Enclosure 13 – RAI Response**RAI Letter Dated August 16, 2017****Documents to be Docketed****NRC QUESTION 1:**

Figure 1 Relationship of Electrical Divisions, FLOW channels, and APRM channels

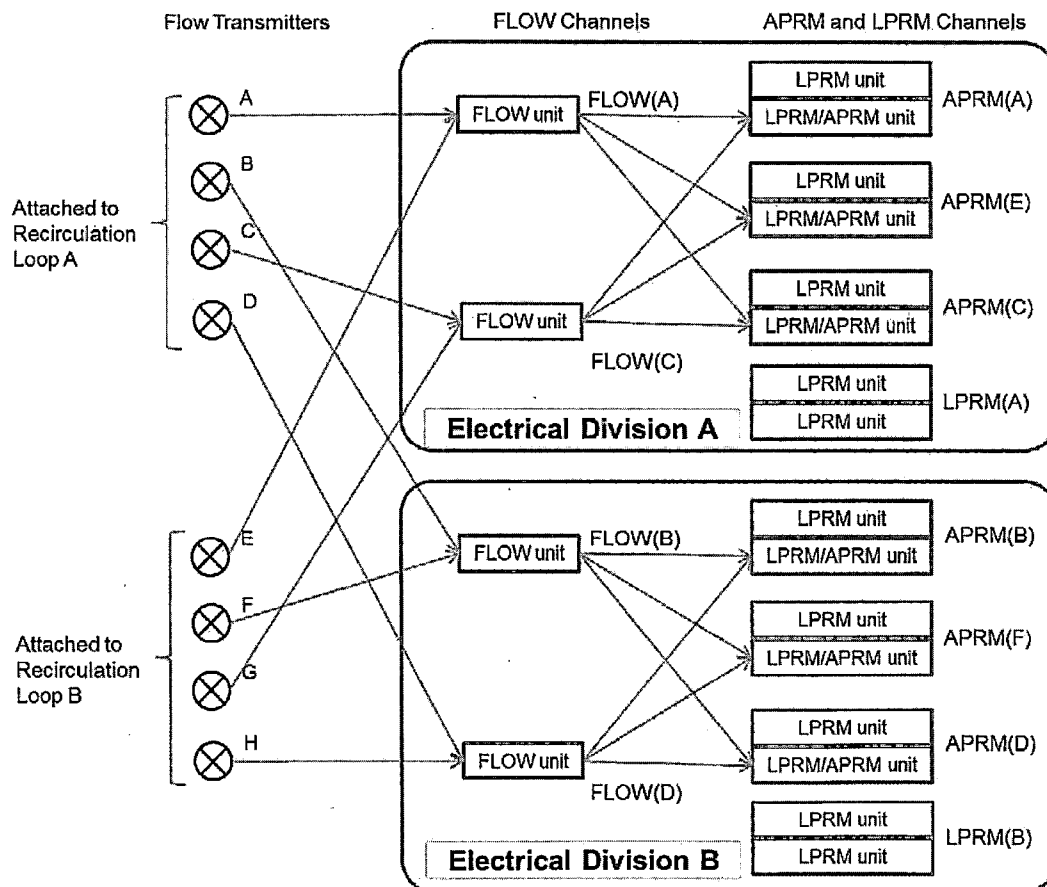
2. (Open Item 80) The licensing topical report (LTR) Section II-2.2.2.3 describes the system configuration. However this section does not describe the configuration for a boiling water reactor (BWR)-5. Instead, the configuration for the BWR-5 is provided in Section II-A-7.1 of the LTR. Also, Section 4.2 of the Equipment Design Specification (EDS) (document No. FC51-3002-1000) identifies the configuration of the Power Range Neutron Monitoring (PRNM) system for one division.

It is the NRC staff's understanding that the description provided in the EDS is for the PRNM system for the Advanced BWR (ABWR), and thus this information can't be used as the configuration for the BWR-5 PRM system. Please address the following:

- Describe the PRM system configuration for each division (i.e., number of local power range monitors (LPRM), units, and modules in each division).
- Provide a figure/diagram showing the PRM system architecture, including the configuration for all divisions. Note that Figures 4-1 in the equipment requirement specification (ERS) and II-A-7-1 in the LTR show the PRM system configuration, but these figures do not identify the separation for each division.

- The BWR-5 PRM system configuration for one channel is shown in Figure II-2-14 in Topical Report (TR) Section II-2.2.2.4. Figure 1 below illustrates the relationship of the electrical divisions, FLOW channels, and the APRM channels described in Section 4.3.1 of the BWR-5 Equipment Requirement Specification (ERS) (FPG-RQS-C51-0001, Rev.7). Each of the BWR-5 electrical divisions has two FLOW units, an LRPM unit, and three LPRM/APRM units. The three LPRM/APRM units are considered three channels.

- b. Figure 1 provides a simple BWR-5 PRM system architecture showing the electrical divisions. As described in LTR Section II-A-7.1, the APRM channels, LPRM channels, and FLOW channels are divided into two electrical divisions in a BWR-5.

For the BWR-5 PRM, Figure 1 in this document shows how each of two electrical divisions (or electrical groups) has the same set of FLOW channels and APRM channels performing the same functions. This configuration meets the redundancy criteria between the divisions and is the digital equivalent of the systems currently installed in the BWRs.

Figure 1 illustrates the configuration of the BWR-5 PRM system. The BWR-5 PRM system is divided into two electrical divisions, each of which has an independent power source. The FLOW and APRM channels in one electrical division operate independently, without receiving any data from the other division. The OPRM channels in a large core BWR use only the data from the division where the OPRM is installed. The OPRM channels in a small core BWR use LPRM data from both divisions (see Toshiba response to NRC Question 6).

Figure 3 Required Response Spectrum

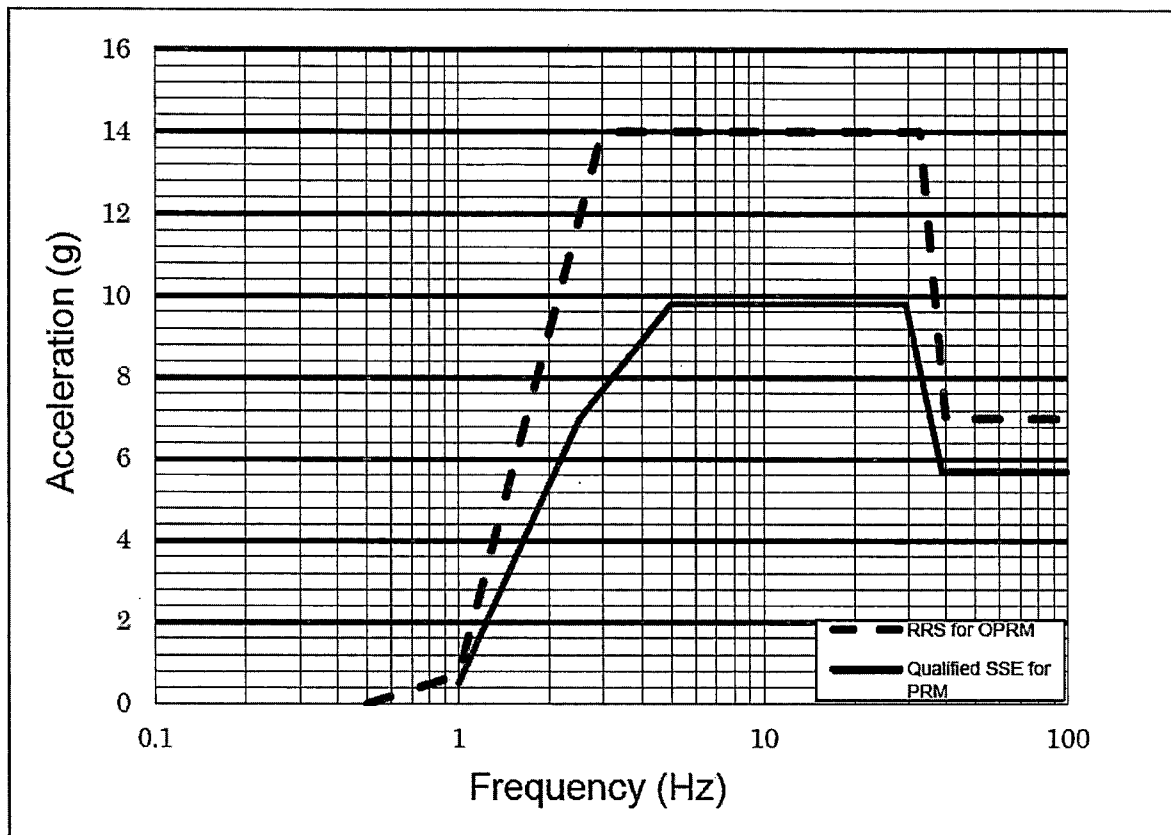
24. (Open Item 105) The Random Multi-Frequency Test results in Appendix A.2 of the Qualification Test Summary Report are hard to read because the gridlines are faint. In addition, the Test Response Spectrum (TRS) fell below the Control Spectrum or Required Response Spectrum (RRS) for at least one point in Figure A.2.6.1. Please provide the following information:

- a. Updated plots in Appendix A.2 of the new version of the Qualification Test Summary Report to show the gridlines or tabulate the breakpoints at one-sixth octave intervals over the frequency range from 1 to 100 Hz for at least Figure A.2.6.1 and one of the operating basis earthquakes (OBEs).
- b. Information on whether Figure A.2.6.1 meets the requirements of Clause 8.6.3.1n of IEEE 344-2004. One point may fall below the RRS by 10 percent provided adjacent 1/6 octave points are at least equal to the RRS and adjacent 1/3 octave points are at least 10 percent above.
- c. An explanation of how the control spectra shown in Appendix A.2 of the Qualification Test Summary Report are consistent with the RRS in Figure II-A-4-5 of the LTR. Additional breakpoints appear to have been added to the EPRI TR-107330 spectrum.

- b. Toshiba planned to conduct the seismic test with the RRS provided in Figure 4-5 of EPRI TR-107330 dated October 1997. The TRS listed in figures in Appendix A.2 of the Qualification Test Summary Report were achievable. Toshiba considers that exceedances below about 3.5 Hz are generally acceptable based on IEEE Std. 344 2004 Section 8.6.3.1(j) since there are clearly no resonances below 5 Hz. Toshiba evaluated the higher frequency area. Toshiba found that Figure 4-5 of a later version of EPRI TR-107330 is slightly different from Figure 4-5 in the original October 1997 version which is the basis for the current Toshiba RRS. Toshiba evaluated the difference. The later version (available from the EPRI website) provides Figure 4-5 with a narrow peak spectral band. Specifically, the 5% damped SSE response spectrum control points of Figure 4-5 of the later version of EPRI TR-107330 are (1 Hz, 0.42 g); (4.5 Hz, 14 g); (16 Hz, 14 g); (33 Hz, 6.13 g); and (100 Hz, 6.13 g). The original version of Figure 4-5 includes a broader frequency. Specifically, the 5 % damped SSE response spectrum break points of this version of Figure 4-5 are (0.5 Hz, 0.1 g); (1 Hz, 0.8 g); (3 Hz, 14 g); (33 Hz, 14 g); (40 Hz, 7 g); and (100Hz, 7 g). The discussion here refers to the version of EPRI TR-107330 Figure 4-5 of the later version of EPRI TR-107330 as the “narrow” spectrum, and the other version of EPRI TR-107330 Figure 4-5 as the “broad” spectrum.

Because of test table limitation of 9.8 g, Toshiba has had to take exception to the EPRI TR-107330 requirement of 14 g in the PRM testing. The PRM testing was conducted at a laboratory where the table could not satisfy the EPRI TR-107330 peak spectral limits. Specifically, the table could only satisfy a peak spectral demand of 9.8 g. PRM test results show that the “narrow” spectrum demand is satisfied with the following exceptions.

Seismic testing for OPRM was conducted at a different facility several years after the PRM testing. The OPRM testing was conducted with the RRS in Figure II-A-4-5 that is based on the “broad” EPRI TR-107330 spectrum to ensure the test table could meet the seismic demand. The test results exceeded the requirements of the broad spectrum with the exception that exceedances in the frequency lower than 3.5 Hz are acceptable based on Clause 8.6.3.1(j) of IEEE Std. 344-2004 since there are clearly no resonances below 5 Hz.

- c. The control spectrum identified in the Appendix A.2 of the Qualification Test Summary Report is based on Figure 4-5 of EPRI TR-107330 dated October 1997. The seismic shake table at the test laboratory was considered. As mentioned above, EPRI Figure 4-5 is slightly different in the later version of EPRI TR-107330. Toshiba will replace Figure II-A-4-5 in the LTR with Figure 3 below adding the explanation that summarizes the discussions in Item b. above, and also replace the corresponding figures in the Qualification Test Summary Report and ERS with the additional explanations so that they will be consistent each other.
